Village of Arlington Heights
Plan Commission
Board Room
Arlington Heights Village Hall
33 S. Arlington Heights Road
Arlington Heights, IL 60005
February 28, 2018
7:00 PM

RE: PARA RESIDENCE - 132 WEST NORTHWEST HIGHWAY - PC#17-015
PUD VARIATIONS

HEART'S PLACE
120-122 EAST BOEGER DRIVE
ARLINGTON HEIGHTS, ILLINOIS

C3.0

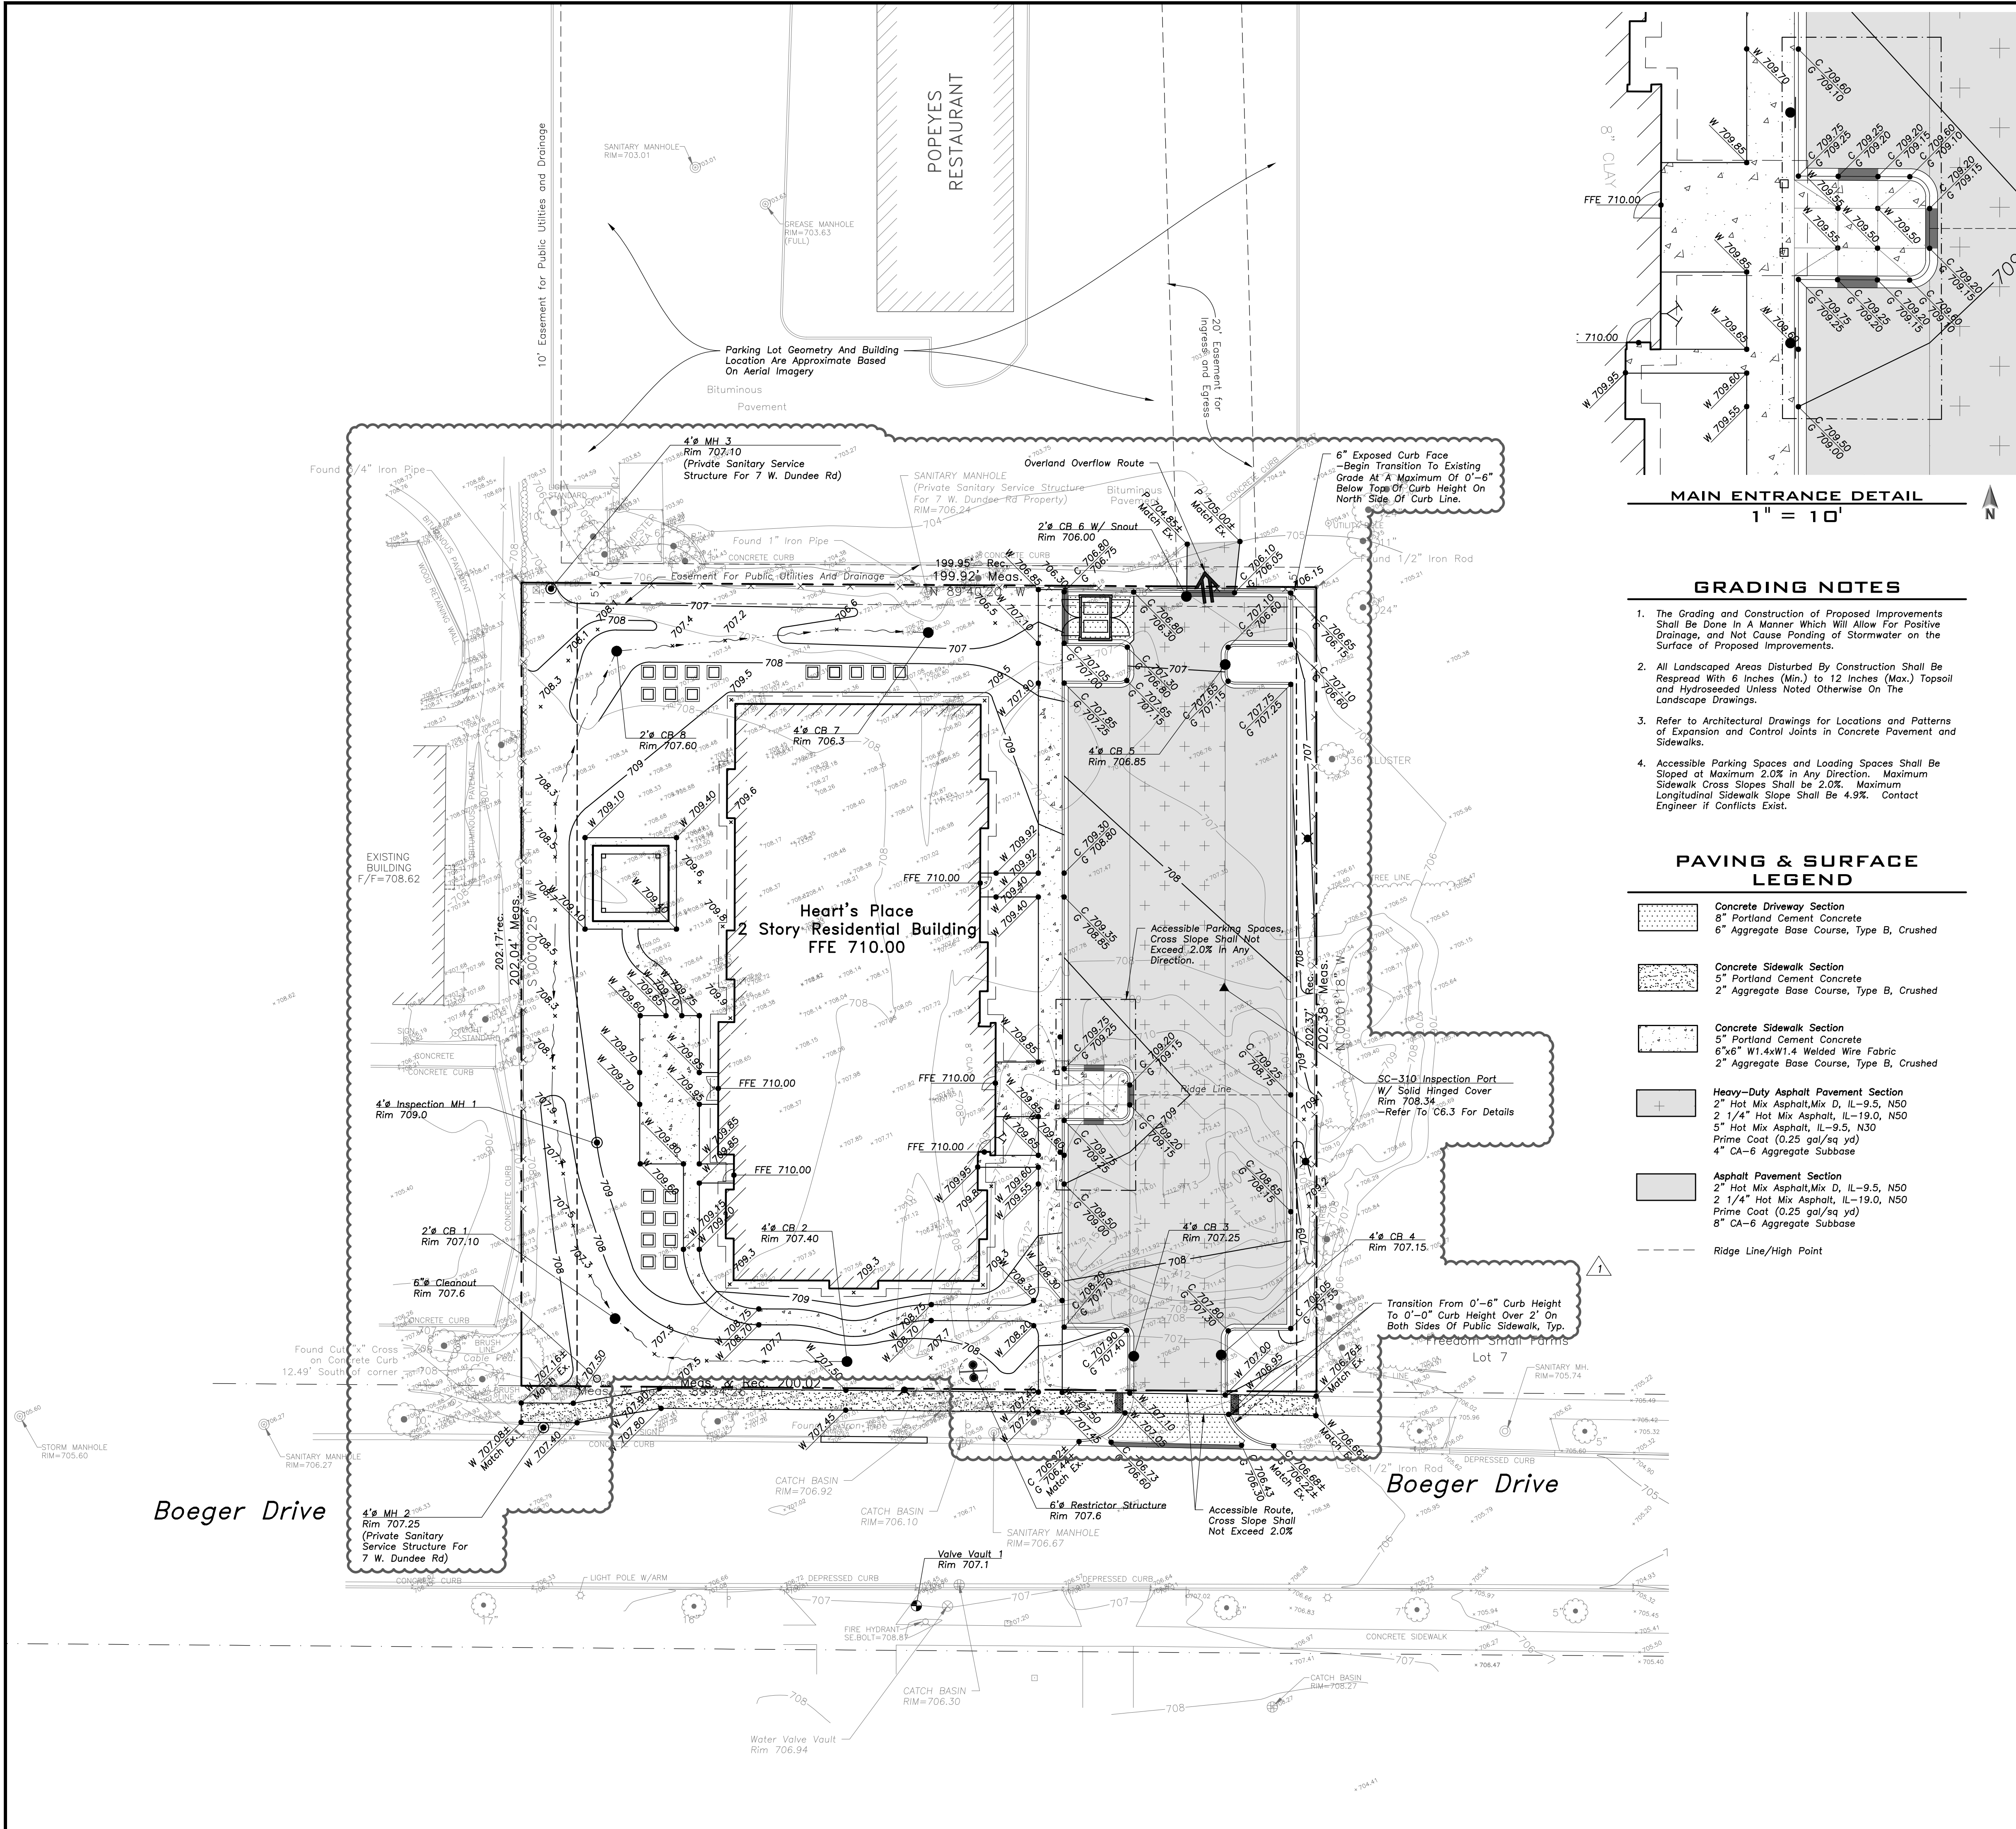
13. Sheet C-3.0: Label the existing pipe inverts to be plugged per MWRD requirements for the two existing sanitary manholes where the existing sanitary sewer main is being removed through the center of the property.

14. Sheet C-3.0: The proposed water service pressure connection shall be contained in a 5' minimum diameter valve vault. Show the valve vault on the plans.

15. Sheet C-3.0: Where will the water meter be located? The service line has an unmetered private hydrant shown.
16. Sheet C-4.0: Show the proposed grading contours along the east side of the parking lot to show how the proposed grading ties into the existing grading on the lot to the east.

CX1.1

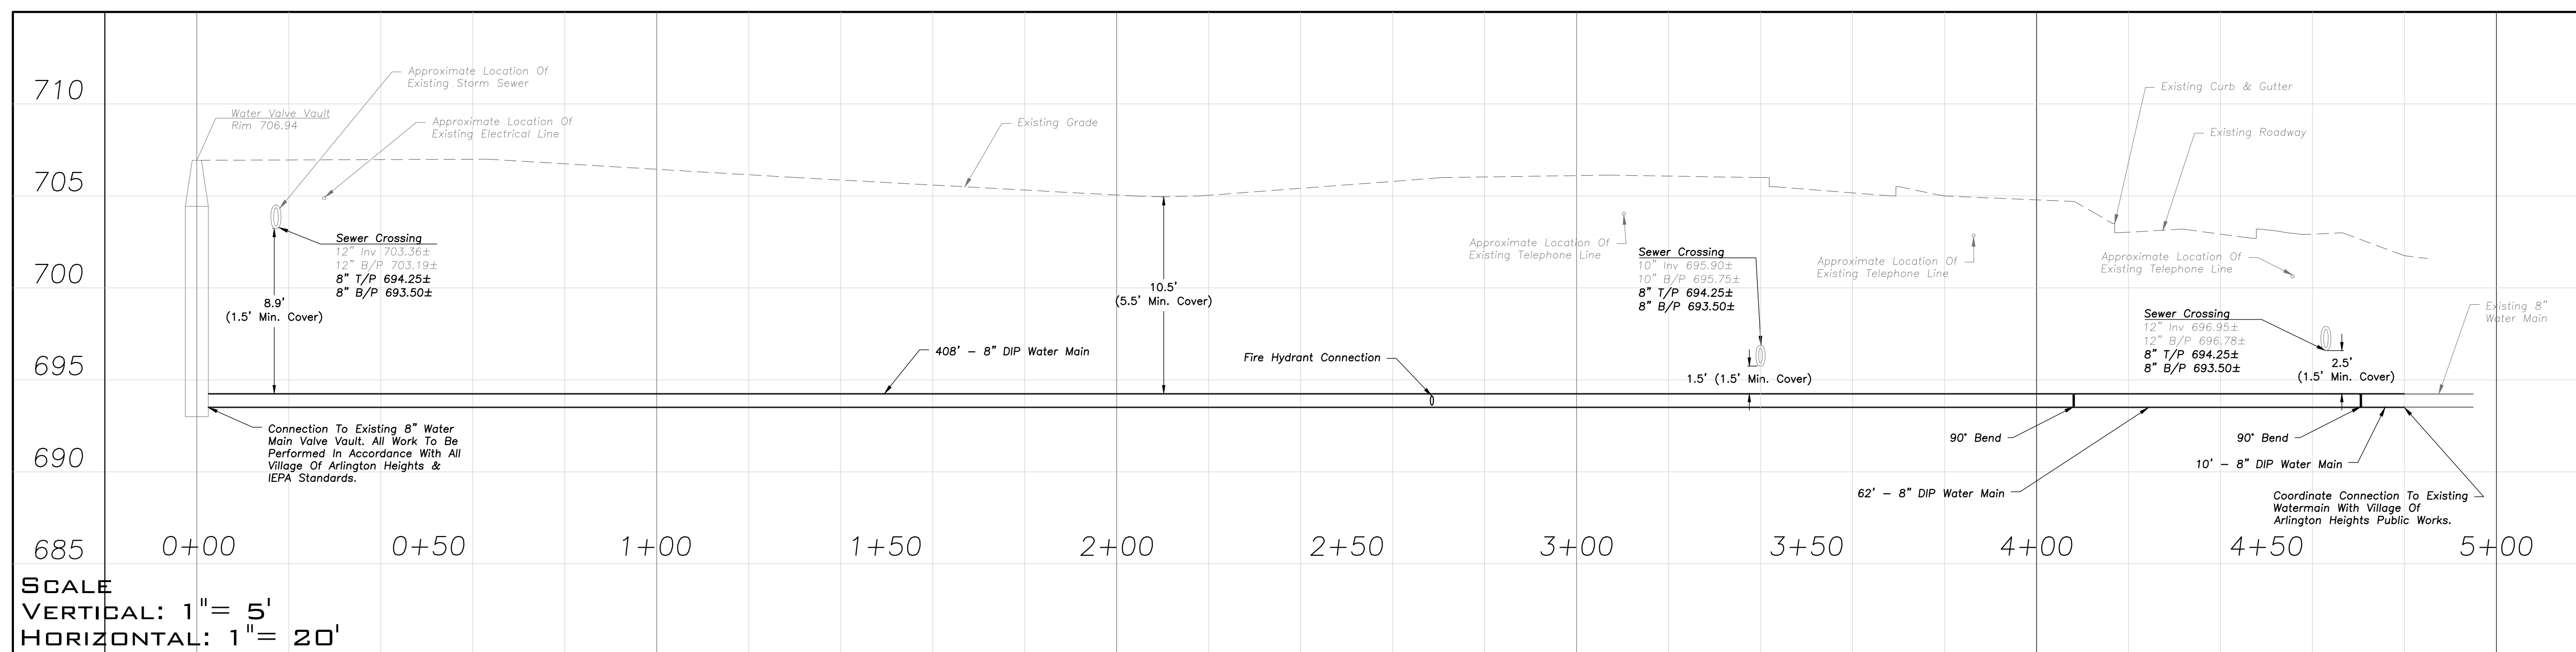
17. Provide cut sheets or plan details from the manufacturer for the proposed StormTech system, including design loading criteria and proposed volume.
18. Sheet CX-1.1: Village Code requires fire hydrants at a maximum spacing of 330'. Add a fire hydrant somewhere between Station 1+50 and Station 2+75 on the new water main extension.

19. Sheet CX-1.1: Verify with the Public Works Department as to how they want the water main connection at the east end of the extension to be designed: whether to use a pressure connection and leave the dead end or eliminate the dead end and install a 90-degree elbow.
